Our Ref: 2922

Your Ref: MP05\_0062 MOD 2

**RE: MODIFICATION REQUEST FOR ROYAL NEWCASTLE HOSPITAL SITE**

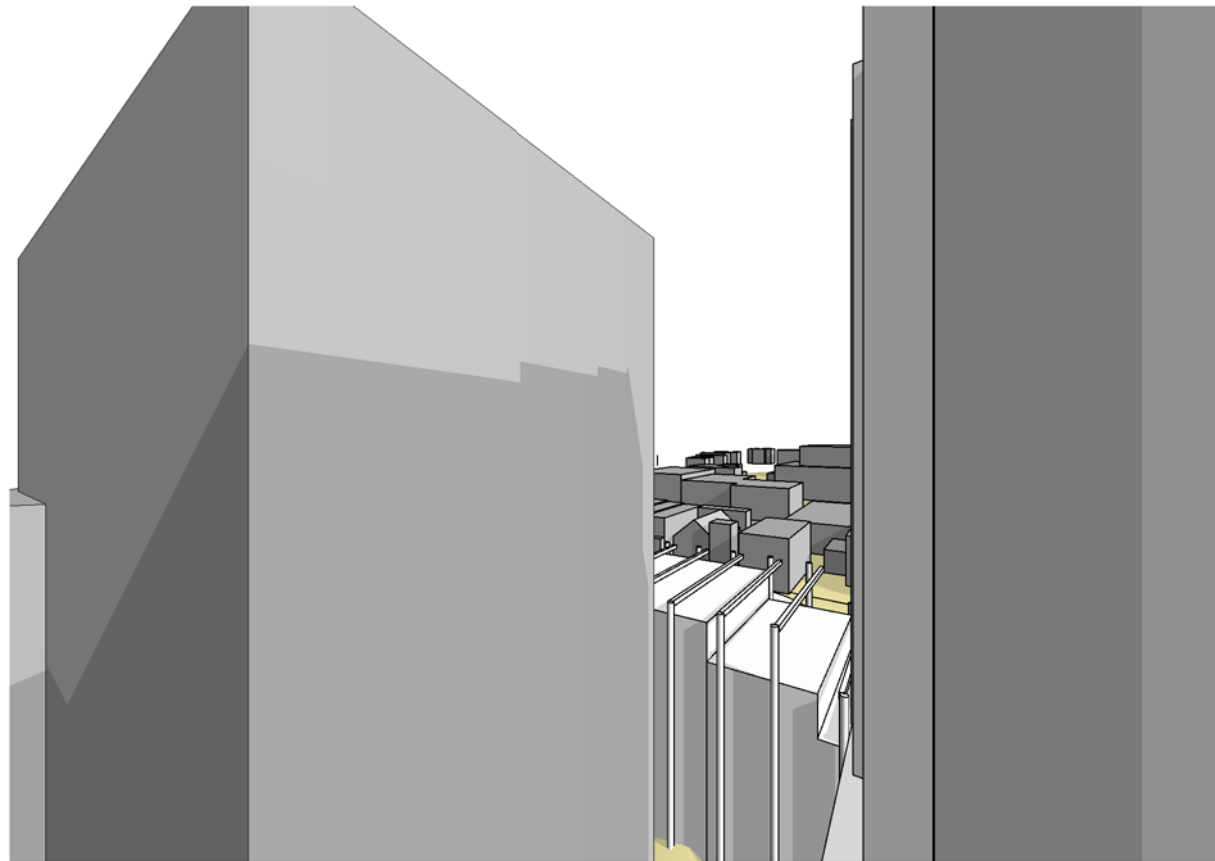
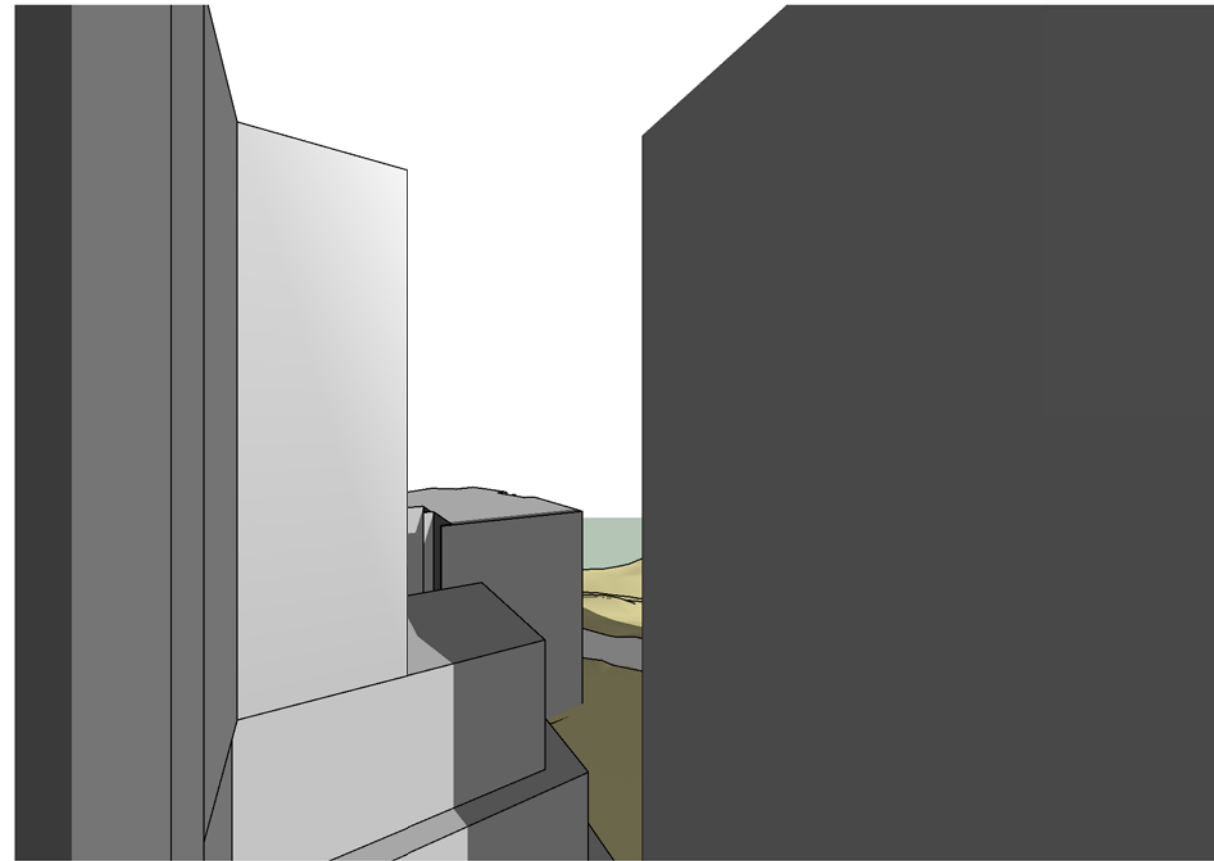
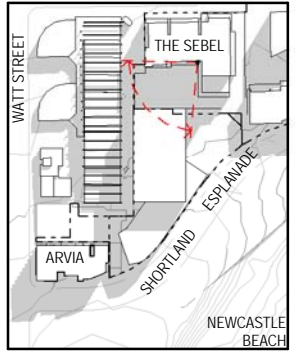
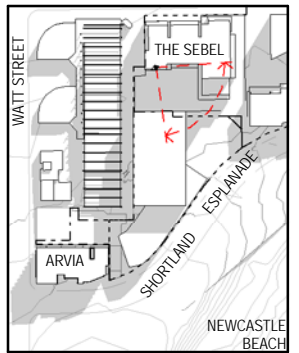
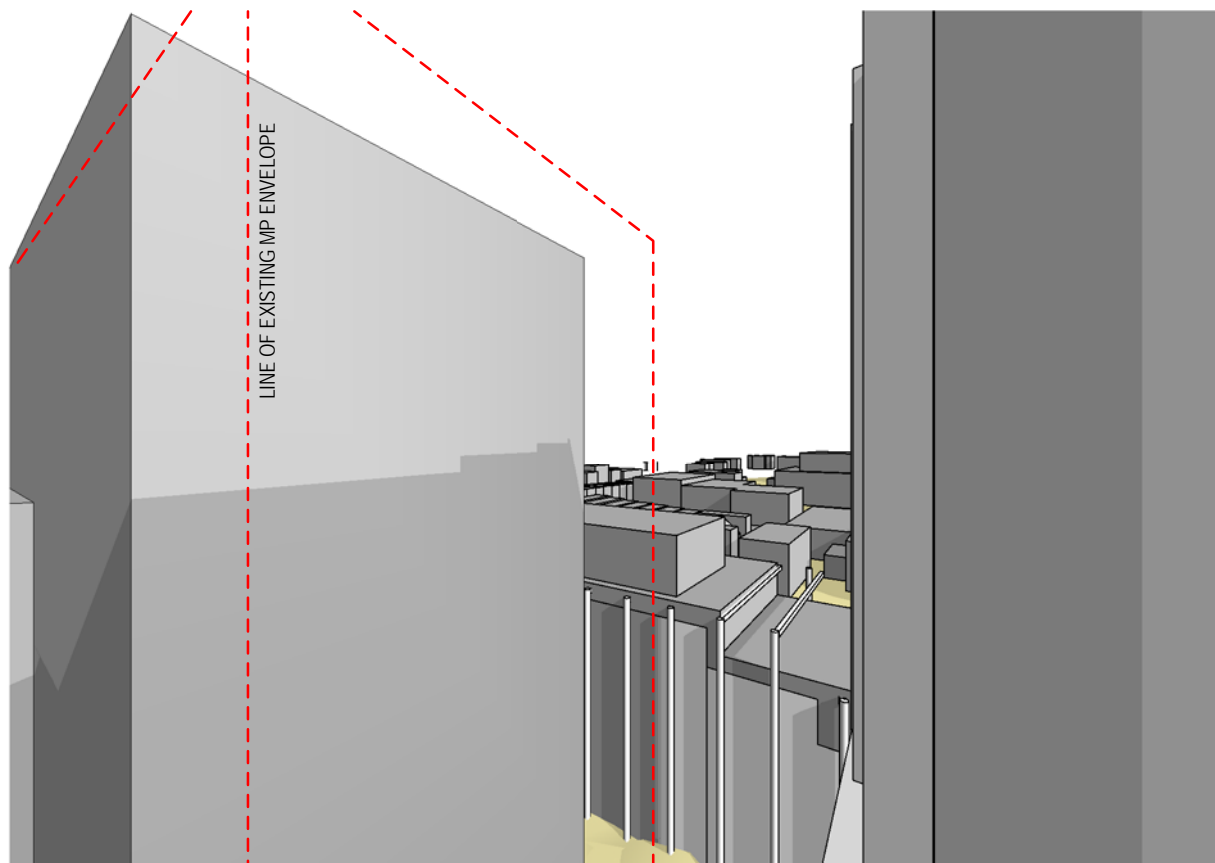
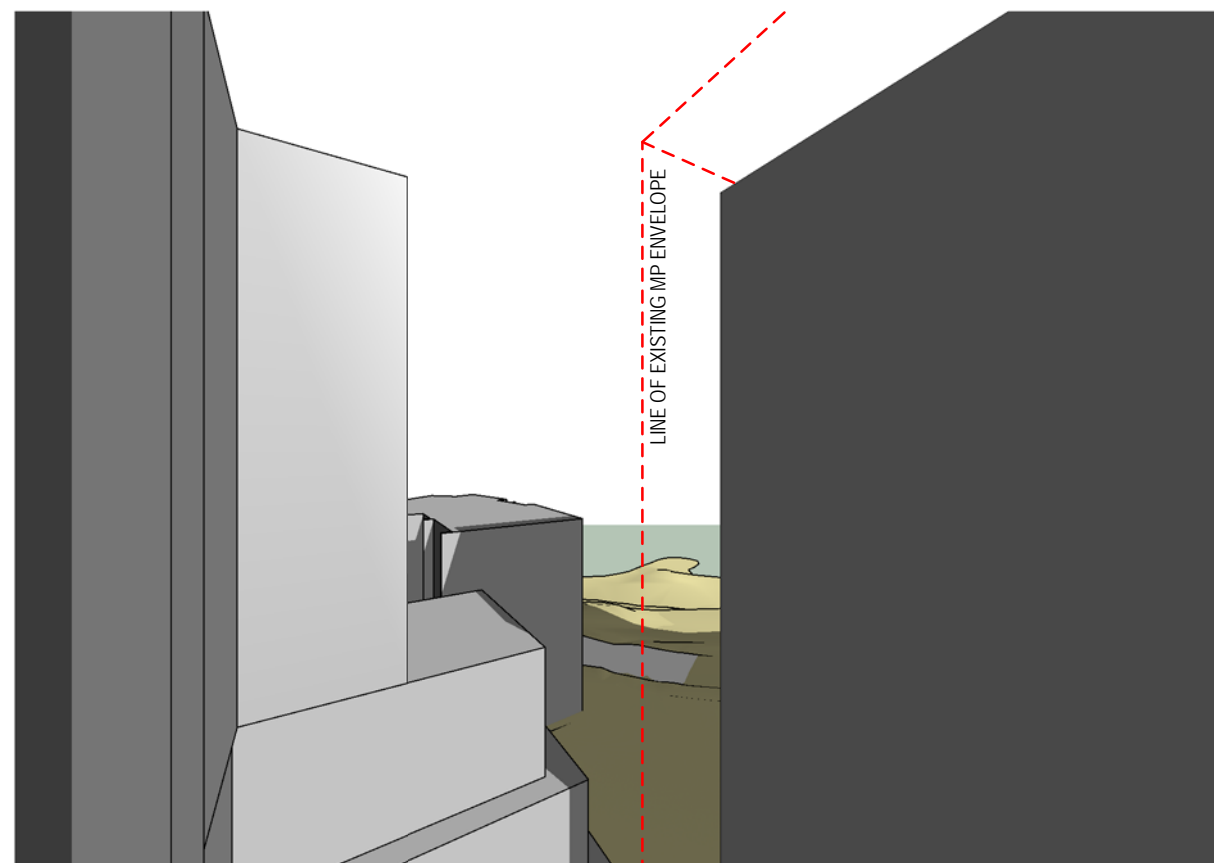
In relation to the completed Mirvac Residential towers to the north, drawings PD 15 Issue C and PD 16 Issue C prepared by Suturs Architects show existing and proposed perspectives taken from two locations within the development (lower and upper) looking west and east. Moving the envelope for the northern building 6.7m further south as proposed, increases the separation between buildings, enhances east and west views and is considered to accord with the view sharing principles set out in *Tenacity Consulting vs Warringah*.

**Communal Open Space Plan prepared by de Witt Consulting**

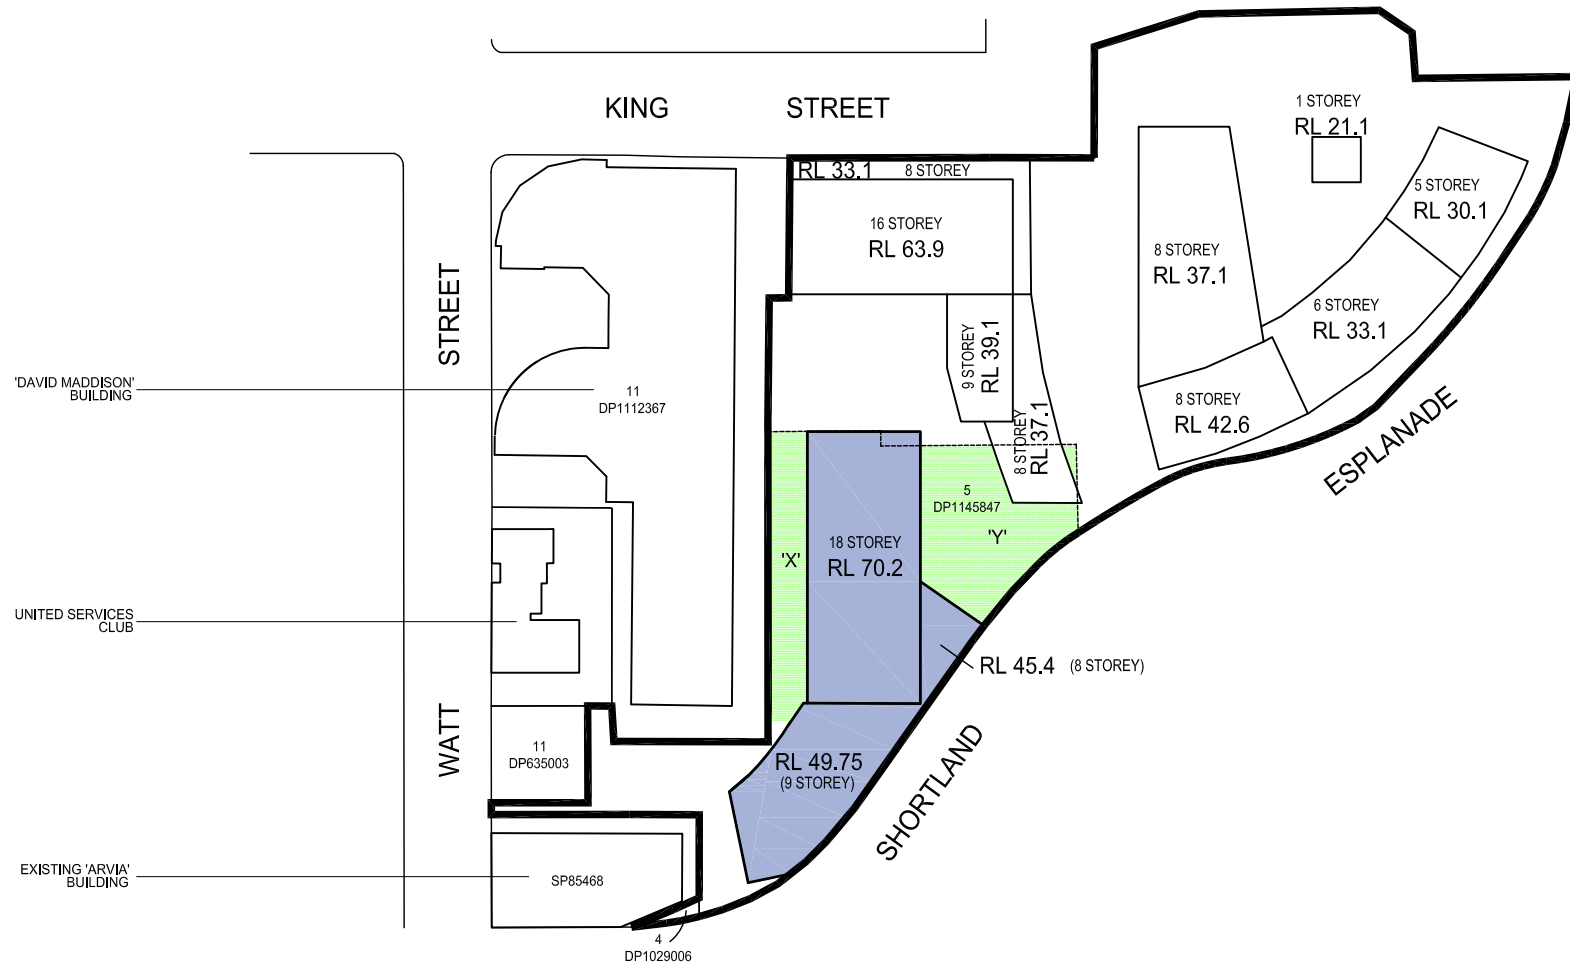
The existing concept plan supporting control drawings show an open area between buildings fronting Watt Street, the Mirvac residential towers to the north and the proposed northern building. We acknowledge that in retaining the David Madison Building and excising it from the concept plan, a proportion of the open space envisaged under the concept plan would be lost. However the proposed amendments to the concept plan include moving the envelope for the northern building 6.7m south (to be consistent with the DA currently before Council). This will allow for increased separation between the northern building and the completed Mirvac residential towers to the north, with the area between these buildings (currently approximately 400m<sup>2</sup>) having the potential to be used as a public plaza. It should also be noted that the open area in front of the Mirvac building is currently 5-6m above the level of the existing laneway to the north. Given this change in levels, a plaza in the manner envisaged in the concept plan would be difficult to achieve.

In terms of the rules of thumb, the area of communal open space should generally be at least between 25 and 30% of the site area. Larger sites and brownfield sites may have the potential for more than 30%. Where developments are unable to achieve the recommended communal open space, such as those in dense urban areas, they must demonstrate that residential amenity is achieved in the form of increased private open space and/or in a contribution to public open space. The Communal Open Space Drawing (**Attachment 5**) shows that the required rule of thumb of 25-30% communal open space can still be achieved outside the Concept Plan building envelope. Based on the drawing, the communal open space area is 1014m<sup>2</sup>, which represents 28% of the site area (3619m<sup>2</sup>).
